UNITED STATES PATENT AND TRADEMARK OFFICE

10/582,405

Office Action Summary	Application No. 10/582,405	Applicant(s) TANAKA, TADAHISA	
	Examiner HENRY LIU	Art Unit 3654

Claim 4 is rejected under 35 U.S.C. 103(a) as being unpatentable over KATOGLI (6,036,612) in view of KERN (5,871,286).

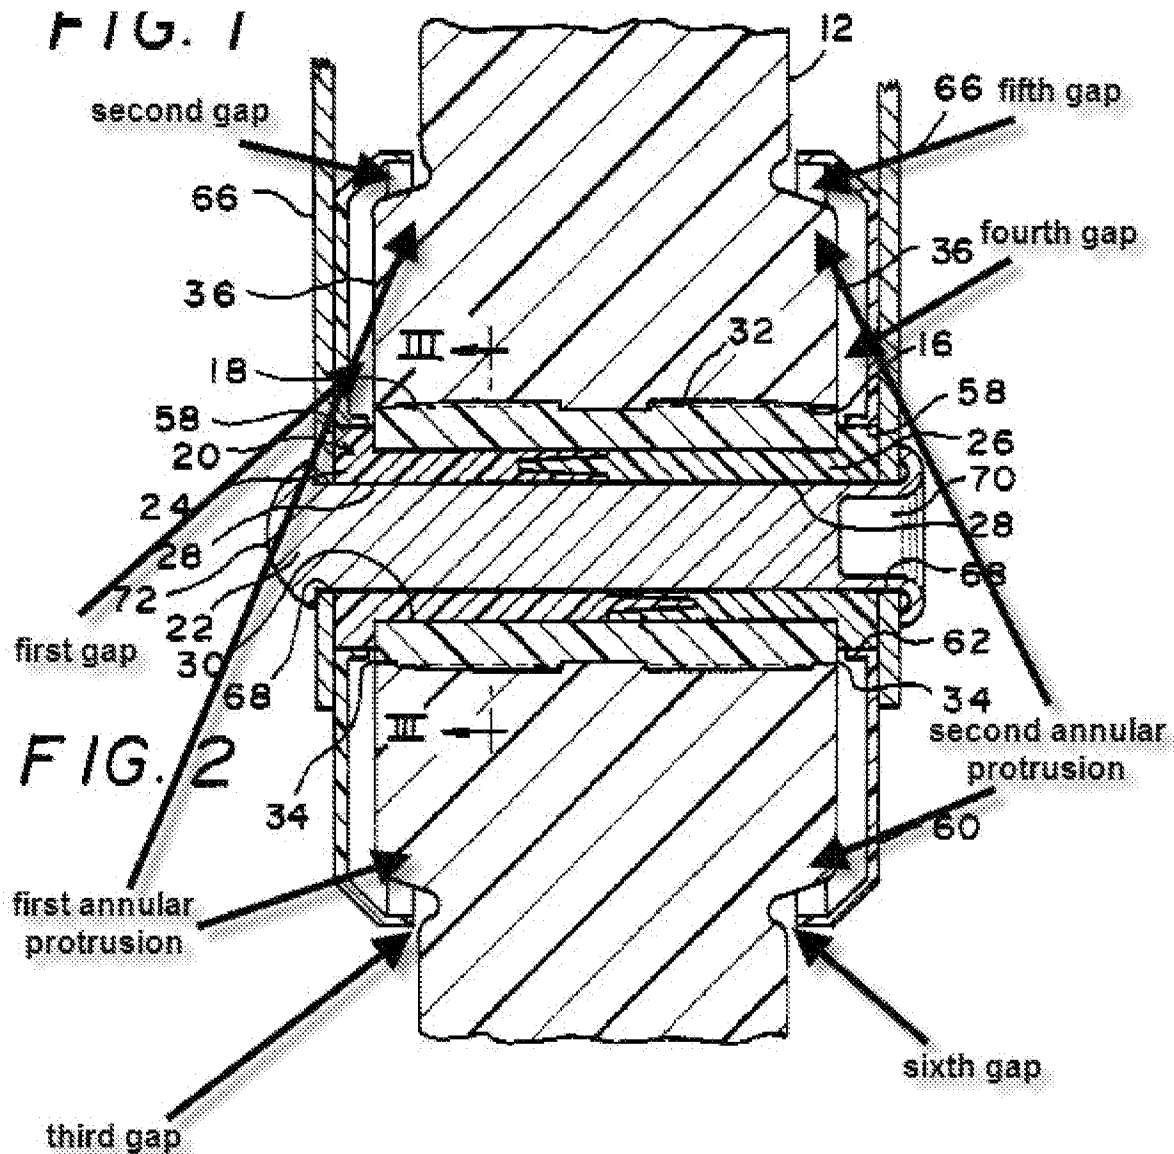
KERN teaches first and second washers (60) (Fig. 2), said first washer (60) comprising a disk portion (Fig. 2) (Fig. 4) disposed between opposed surfaces of said bushing (18) and said pulley arm (64), and a cylindrical portion (Fig. 2) (Fig. 4) axially

extending from a radially outer edge of said disk portion of said first washer toward said second washer such that said cylindrical portion of said first washer has a distal end with an axially-facing end surface (Fig. 2) (Fig. 4), said second washer (60) comprising a disk portion (Fig. 2) (Fig. 4) disposed between opposed surfaces of said bushing (18) and a head of said rivet (22), and a cylindrical portion axially extending from a radially outer edge of said disk portion of said second washer toward said first washer such that said cylindrical portion of said second washer has a distal end with an axially-facing end surface (Fig. 2) (Fig. 4); wherein said coupling piece (36) has first and second annular protrusions each formed at one of two open ends of said bushing insertion through hole; wherein said first annular protrusion has an axial end surface axially facing said disk portion of said first washer with a first gap between said disk portion of said first washer and said axial end surface of said first annular protrusion, and a radially outer surface radially facing said cylindrical portion of said first washer with a second gap between said cylindrical portion of said first washer and said radially outer surface of said first annular protrusion, said first annular protrusion defining a first recess radially outside thereof which has an axially-facing bottom that axially faces said axially-facing end surface at said distal end of said cylindrical portion of said first washer with a third gap between said axially-facing bottom of said first recess and said axially-facing end surface at said distal end of said cylindrical portion of said first washer, said first, second and third gaps communicating with each other so as to define a first labyrinth; and wherein said second annular protrusion has an axial end surface axially facing said disk portion of said second washer with a fourth gap between said disk portion of said

second washer and said axial end surface of said first annular protrusion, and a radially outer surface radially facing said cylindrical portion of said second washer with a fifth gap between said cylindrical portion of said second washer and said radially outer surface of said second annular protrusion, said second annular protrusion defining a second recess radially outside thereof which has an axially-facing bottom that axially faces said axially-facing end surface of said distal end of said cylindrical portion of said washer with a sixth gap between said axially-facing bottom of said second recess and said axially-facing end surface at said distal end of said cylindrical portion of said second washer, said fourth, fifth and sixth gaps communicating with each other so as to define a second labyrinth. See figure below.

It would have been obvious to one of ordinary skill in the art at the time the invention was made to modify the tensioner in KATOGLI with the bearing assembly in KERN to create a tensioner with bearings which are protected from foreign objects.
